**Northeast
Utilities**

Re: Docket No. CSC 424 - Interstate Reliability Project

Response to CSC-01 Interrogatories dated 03/09/2012

CL&P Divisions and Facility Locations

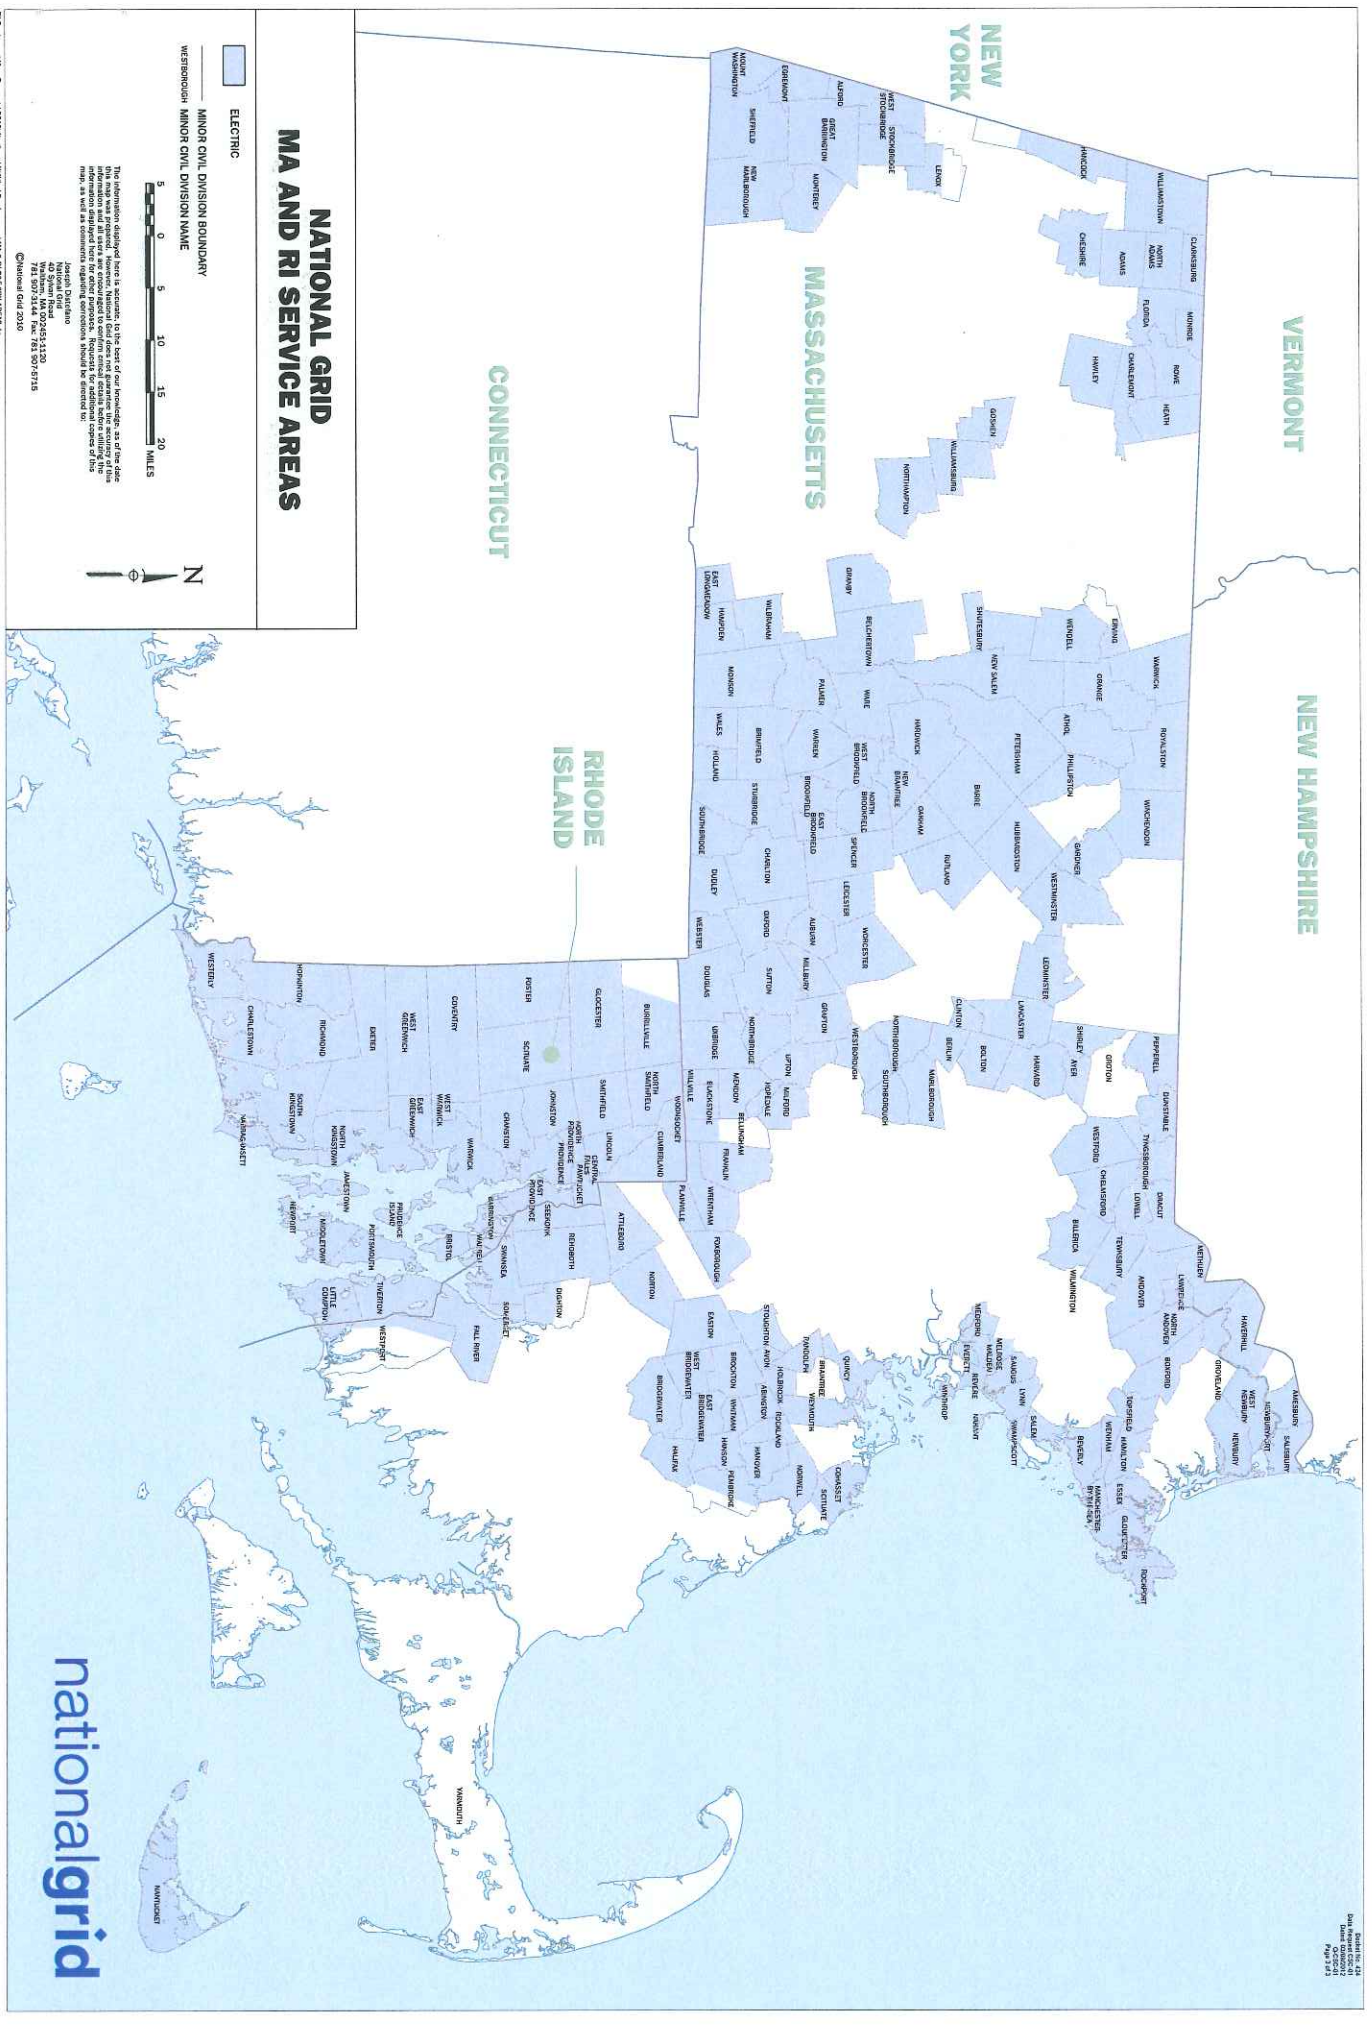
Question:
What is the geographical territory of each of the companies involved in the proposed Interstate project?

Towns shaded with a non-white color on the Connecticut map that is page 2 of 3 of this response represent the CL&P service territory. Similarly blue-colored towns on the Rhode Island and Massachusetts map that is page 3 of 3 of this response represent the National Grid USA service territory in those two states. National Grid USA's affiliate, The Narragansett Electric Company, serves customer load in Rhode Island. Two other National Grid USA affiliates, the Massachusetts Electric Company and the Nantucket Electric Company, serve customer load in Massachusetts. The New England Power Company holds the transmission assets of National Grid USA and provides services to the three affiliate companies in Massachusetts and Rhode Island. The New England Power Company also controls National Grid USA transmission assets in New Hampshire, where its affiliate company, Granite State Electric, serves customer load, and in Vermont.

**New England
East-West
Interface
345-kV lines**

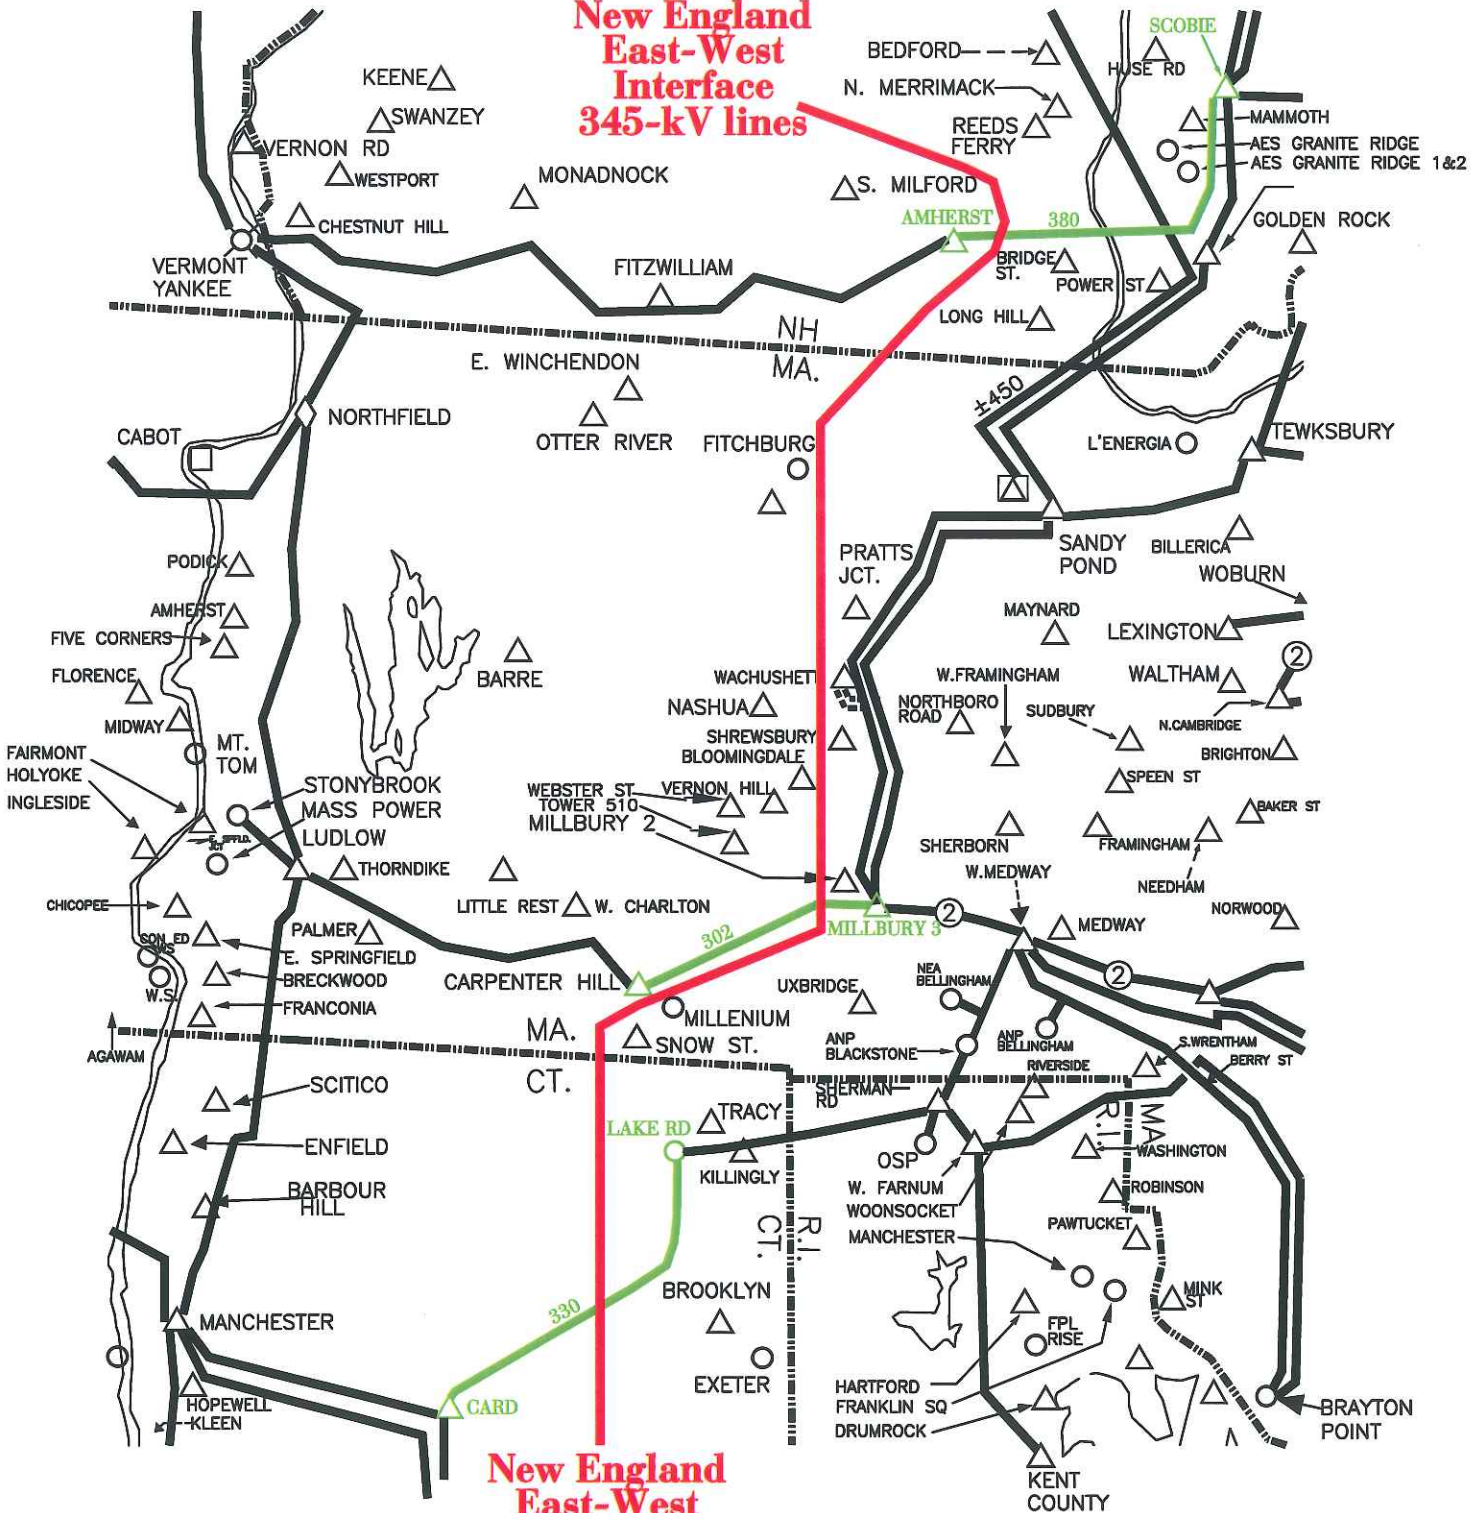
Question:
What existing 345-kV lines currently cross the New England East- West Interface?

There are three 345-kV transmission lines that currently cross the New England East-West Interface. These three lines are shown with green coloring on a geographic map on page 2 of 2.
